Review of the Ocean Science manuscript “Documenting the 2015-2017 freshening of the eastern Eurasian Basin of the Arctic Ocean and evaluating its drivers and consequences” by Dolly More and Igor Polyakov

- 24) Line #360 (Figure 11):

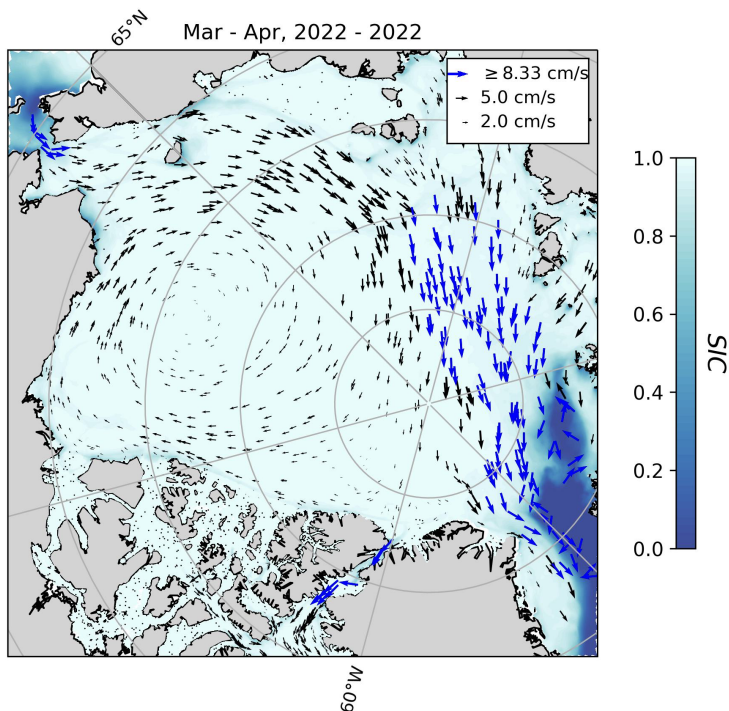
For M1₁, the maximum correlation was reported at a 7-month lag, whereas the graph appears to show a maximum around 22 months, similar to M1₃–M1₅ and M3. The authors should clarify why the 7-month lag was chosen. For M1₂, there is a relatively flat plateau between 9 and 23 months, indicating some uncertainty. I recommend adding confidence intervals (e.g., shaded areas) to each correlation panel to better convey this uncertainty. Overall, it would strengthen the figure and interpretation to acknowledge that a lag of ~22–23 months likely applies across all mooring records.

A minor point: there is a small inconsistency between the text (Line #354, “*all statistically significant at 95% level*”) and the figure (significance level $p < 0.001$). If all correlations indeed meet the $p < 0.001$ threshold, it is acceptable to state 99.9% confidence level in the text.
